BUILDING SCOPE ADDENDUM NO. 01

This Addendum is a summary of clarifications, interpretations, corrections and/or modifications to the Contract Documents for the Conestoga High School Athletic Fields Project prepared by Heckendorn Shiles Architects.

DRAWING NUMBER
A102

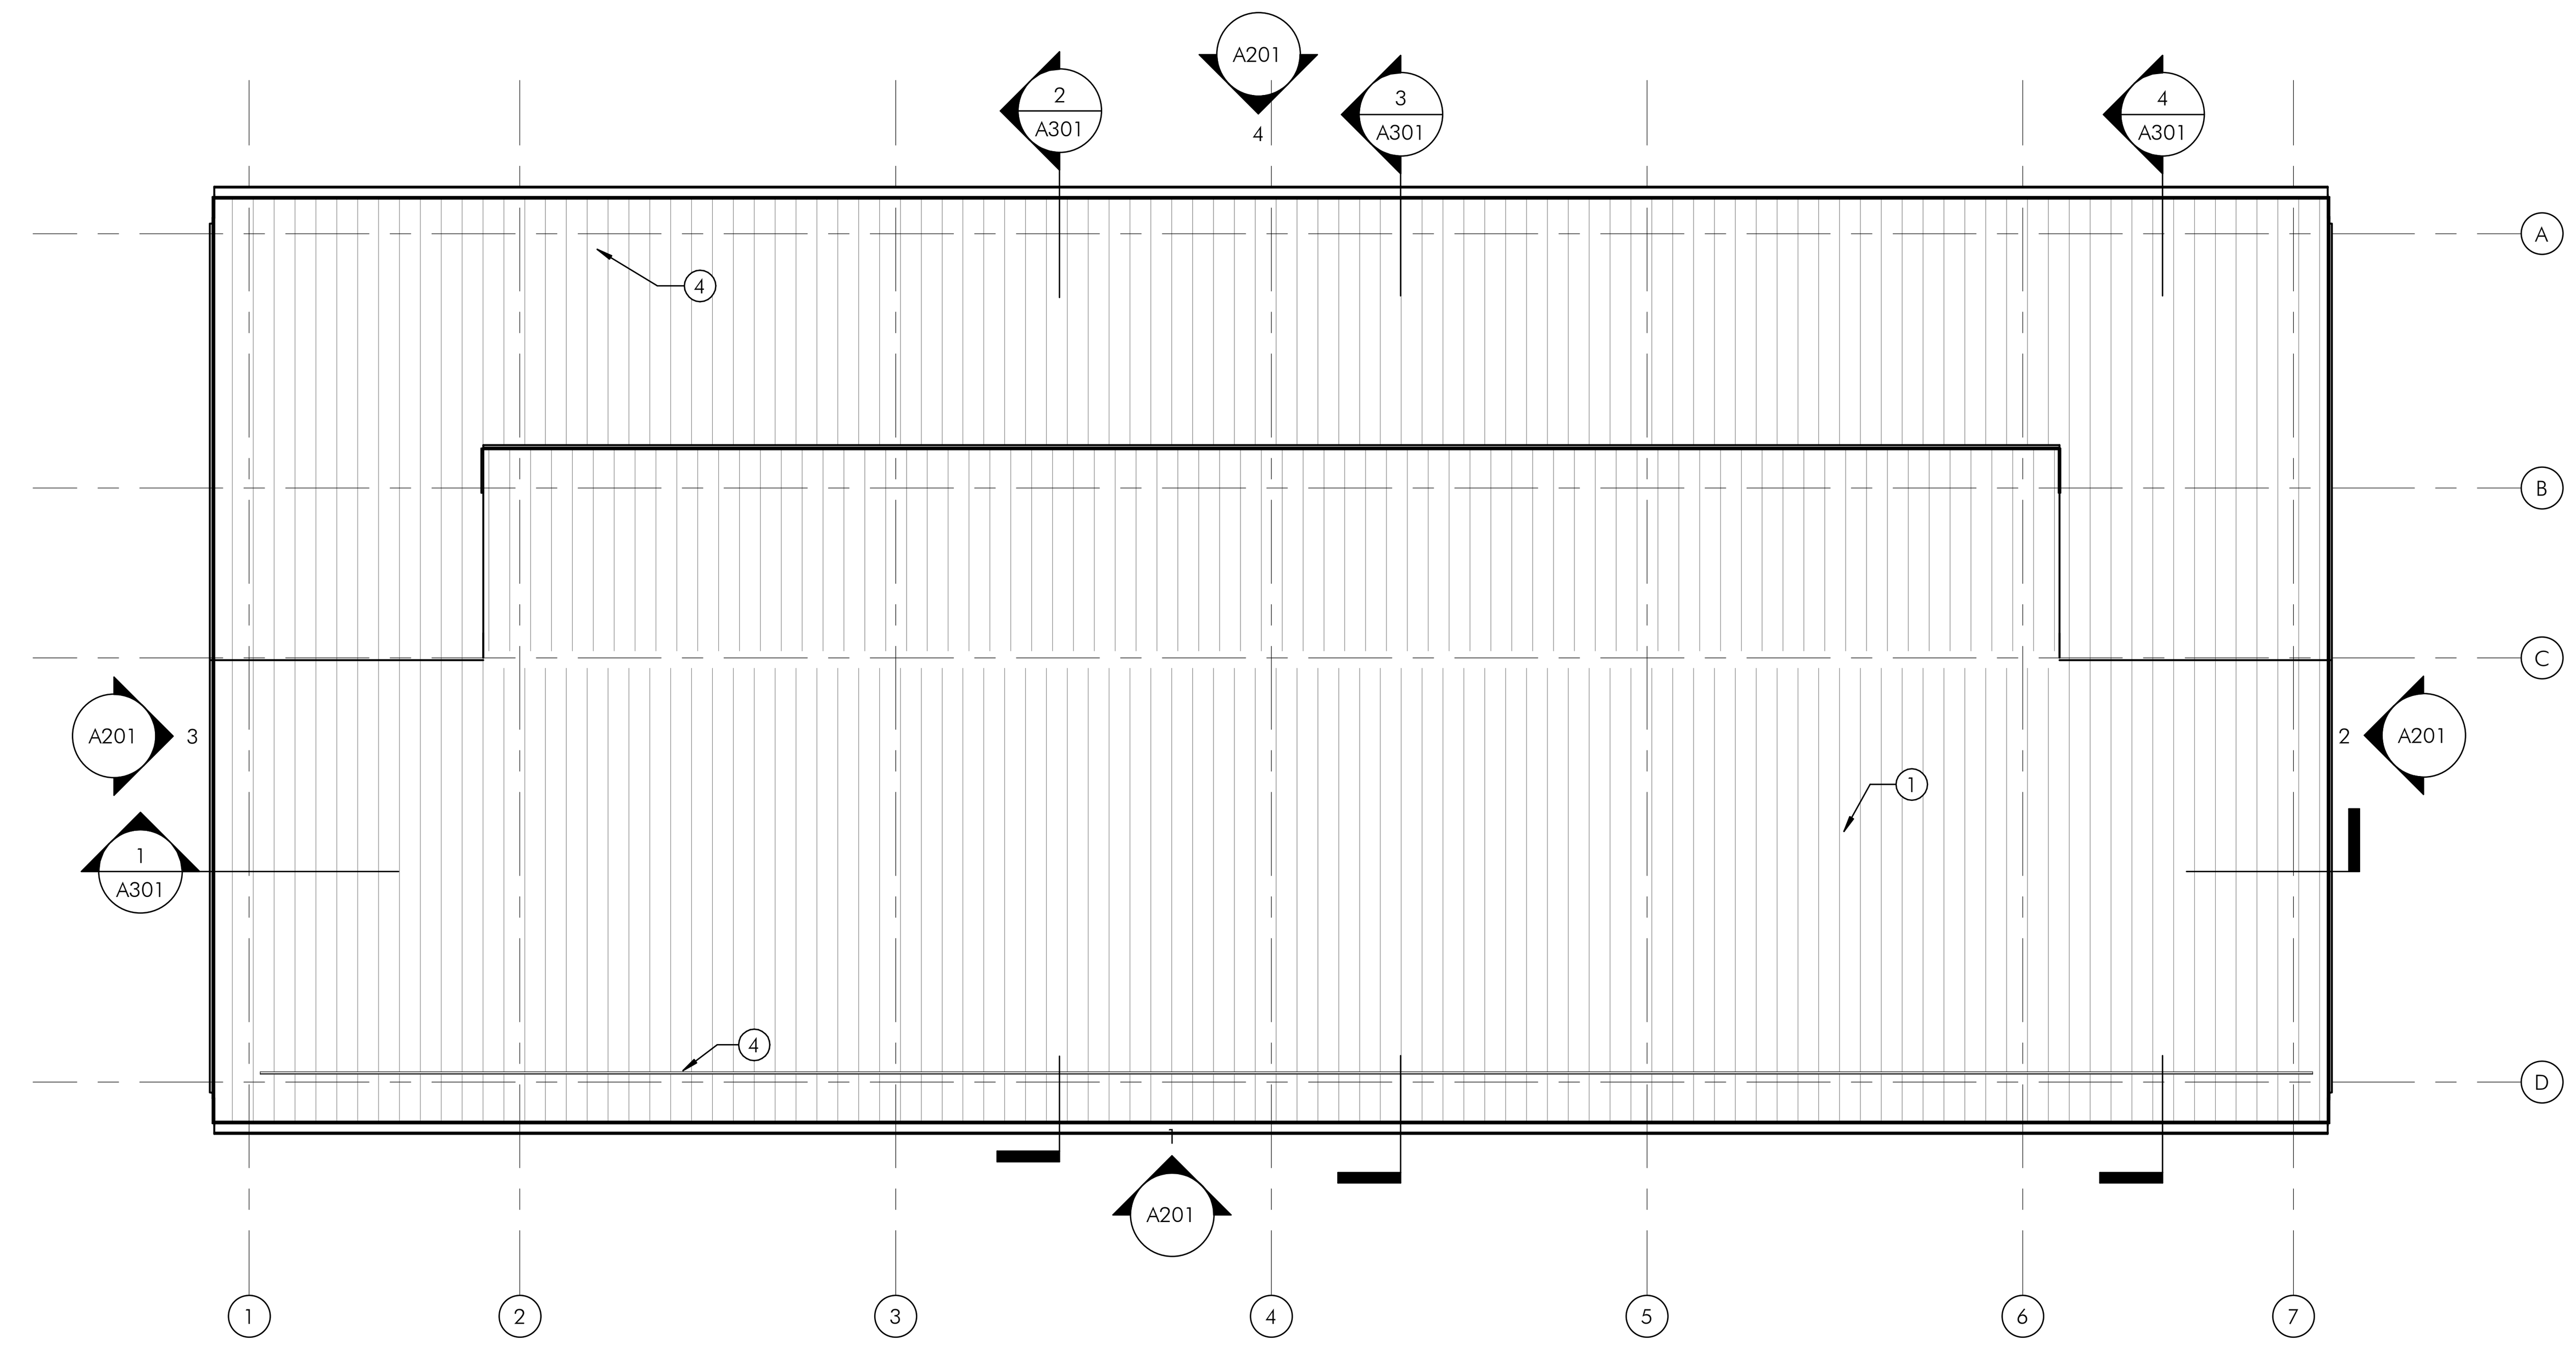
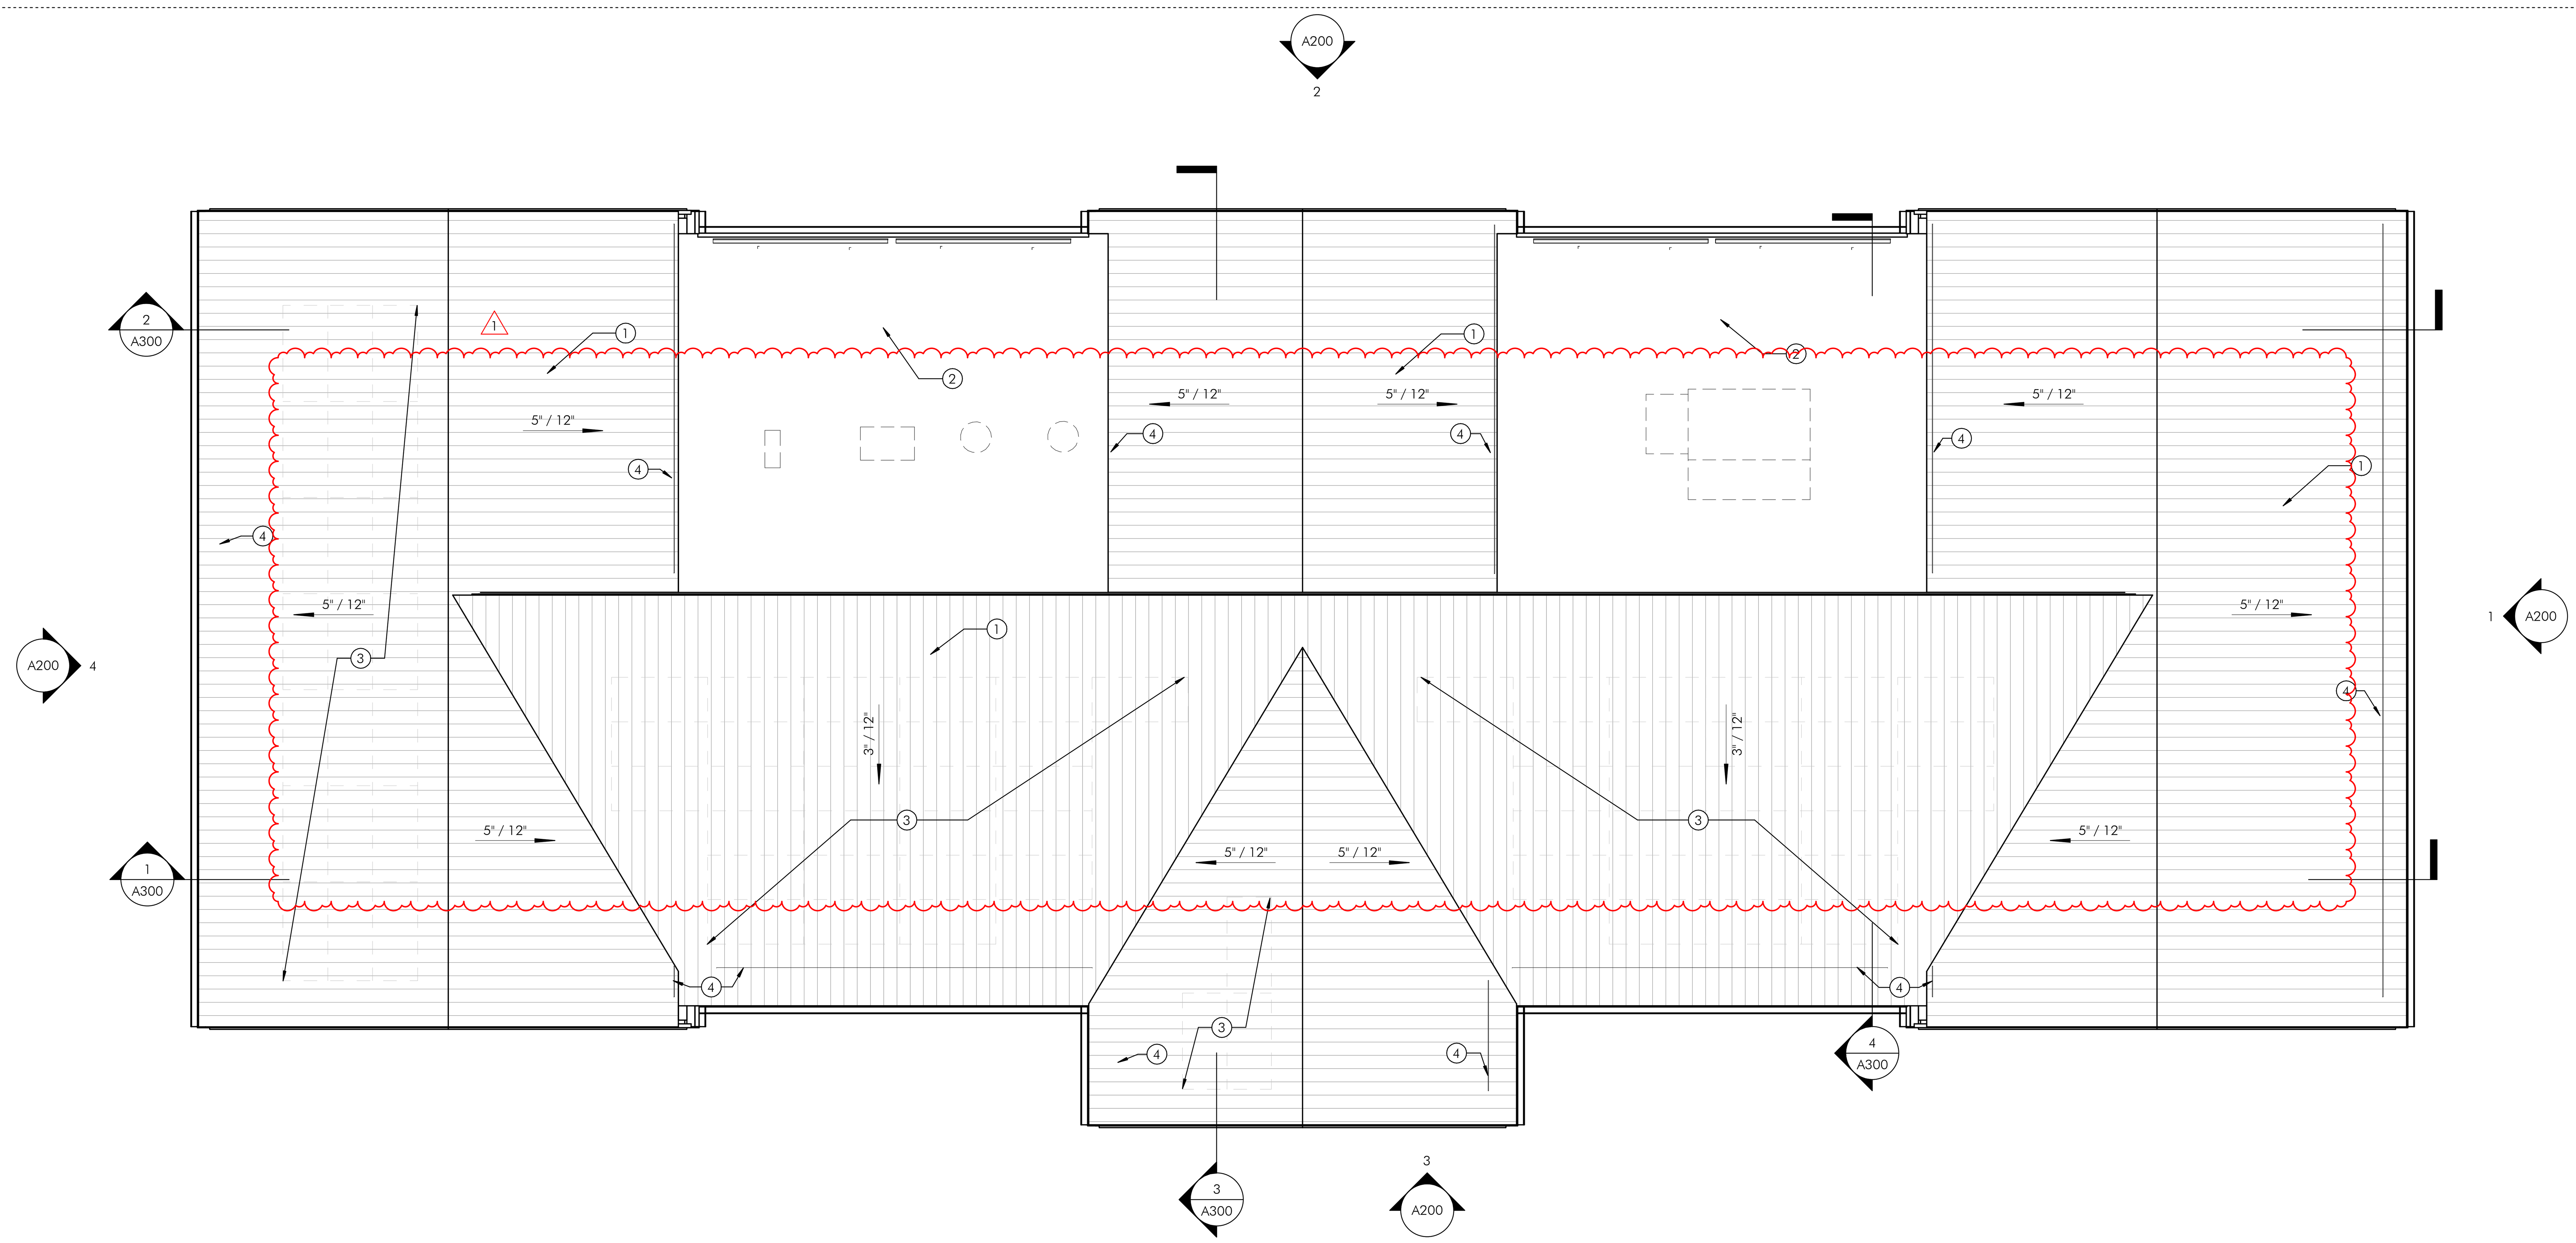
15. Question: After looking at the drawings, there are some details missing that would help us provide an accurate quote on the roof trusses for the field house. Please provide/refer us to the following information: 1. Roof pitches 2. Overhang lengths 3. Heel heights 4. Did you want OSB on the gables?
    Response: Roof pitches, Overhang lengths, and heel dimensions have been provided in the updated sheets attached to the addendum. The gables are masonry and do not need to be OSB.
